Delegated Report

Householder Planning Application

Planning Application No: 20240966

Description: Formation of a vehicular access, engineering operation, including new steps and new retaining wall, to facilitate hardstanding area.

Pedestrian Visibility Splay
Scale 1:50

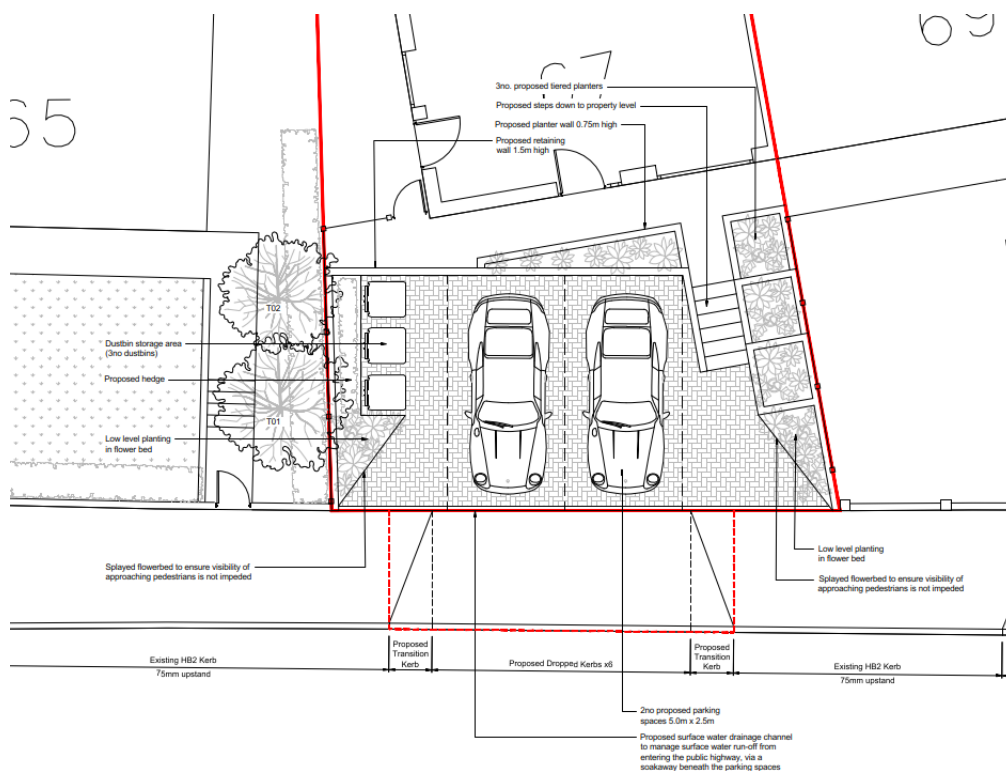
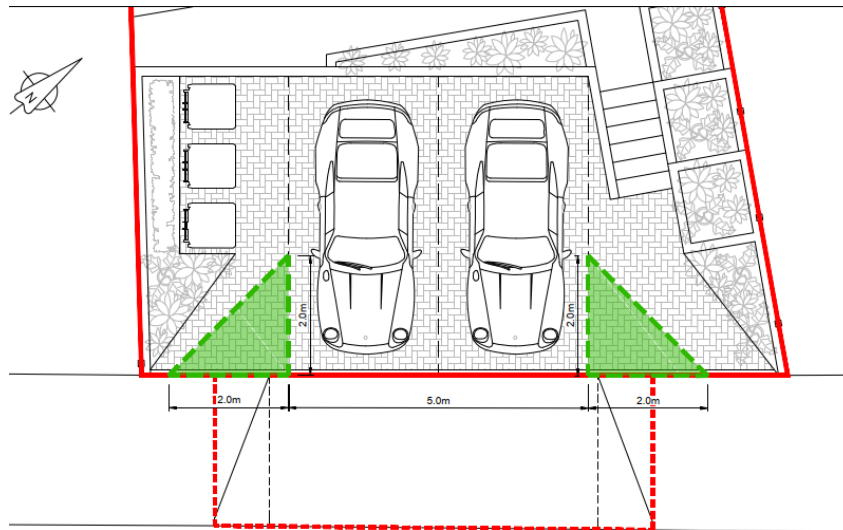
Furthermore, it is noted that the proposed soft landscaping has been strategically placed, and the plans incorporate 2.00m x 2.00m visibility splays on both sides, in the interests of highway safety.

Proposed Street Scene
Scale 1:50

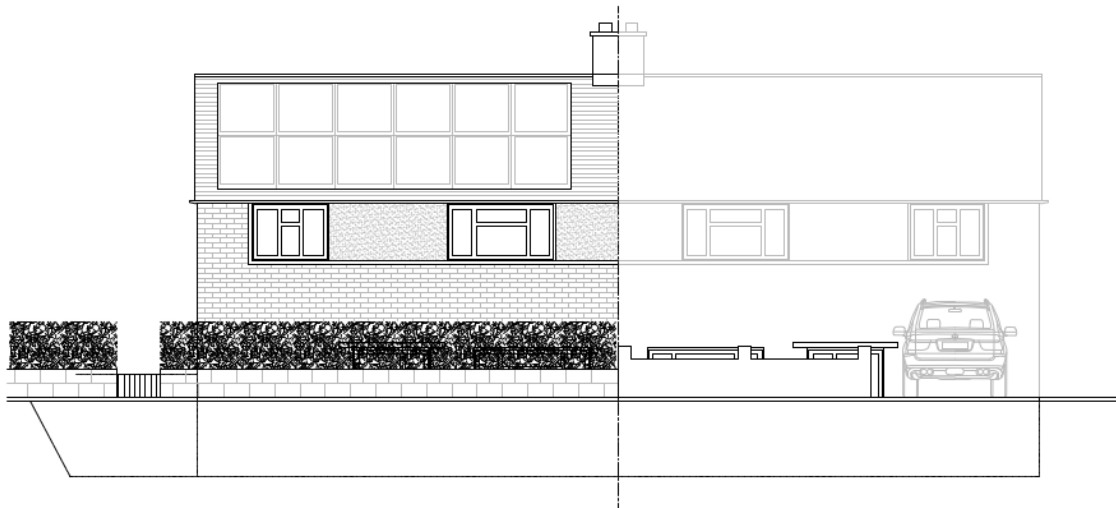
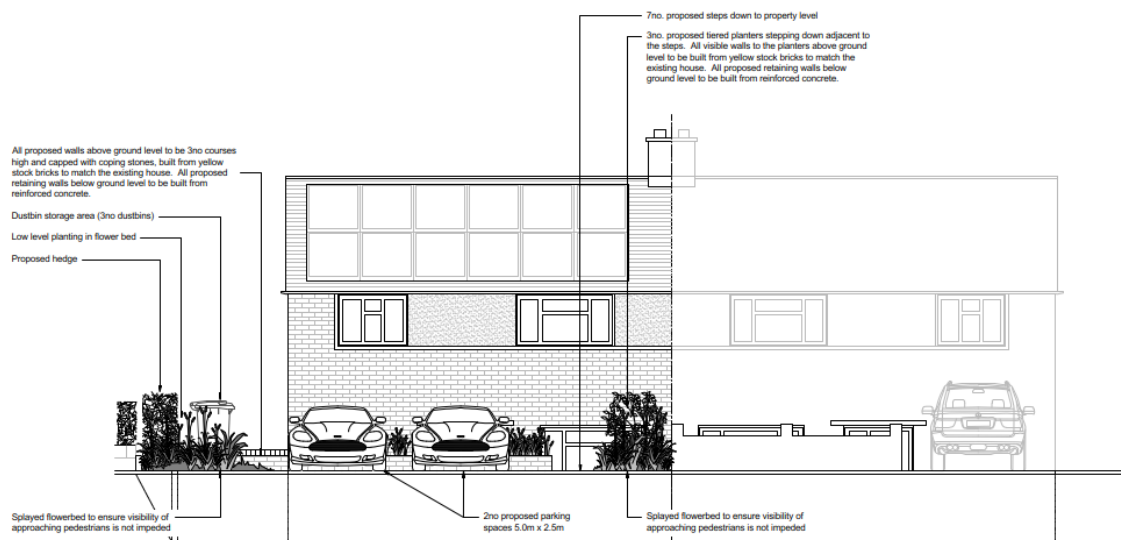
The revised plans provided for this application are considered to be an improvement on the previous submission. The number of parking spaces have been reduced, allowing for layout changes, including relocation of the bin area (which would be partially screened from view) and additional planting to soften the development. In addition, the visible brickwork would be yellow stock bricks to match the existing dwelling.

Figure 6: Proposed layout in current application showing additional planting to reduce the large expanse of block paving and soften the design with strategic planting.

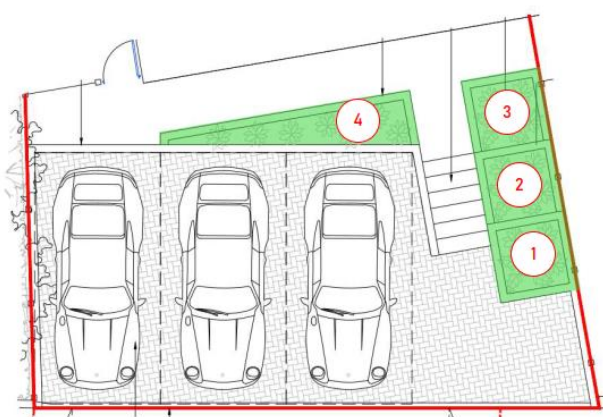
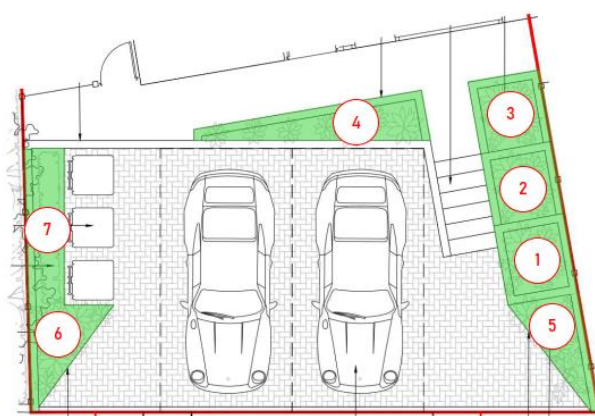
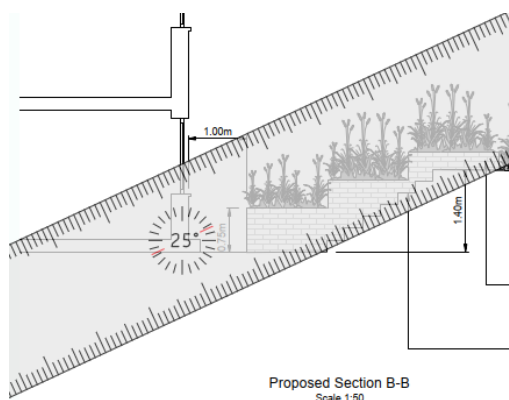
Figure 5: Proposed layout in Refused application showing four raised planters, deemed by Gravesham to be too few in proportion to the hard landscaping

- 1 Raised planter, 1.0m x 1.2m x 0.3m high min, 0.48m max.
- 2 Raised planter, 1.0m x 1.2m x 0.3m high min, 0.48m max
- 3 Raised planter, 1.0m x 1.2m x 0.3m high min, 0.75m max
- 4 Raised planter, 0.2m wide min, 1.0m max, x 4.5m x 0.75m high
- 5 Flower bed at ground level, 1.2m x 2.2m
- 6 Flower bed at ground level, 1.5m x 2.0m
- 7 Proposed hedge to match existing, 3.0m long, 1.0m wide, 1.5m high

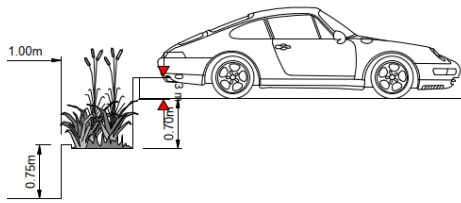
SPG 4 - KCC Parking Standards (2006) and Gravesham's Householder Extensions/Alterations Design Guide (2021) state that car parking spaces need to be a minimum of 2.50m wide (2.7m where spaces adjoin an enclosed boundary) and 5.00m deep. The plans show that the hardstanding area would provide sufficient parking area for two cars. In addition, the retaining wall directly behind the spaces has been increased since the previous submission, from 0.15m to 0.30m, which is considered positive:
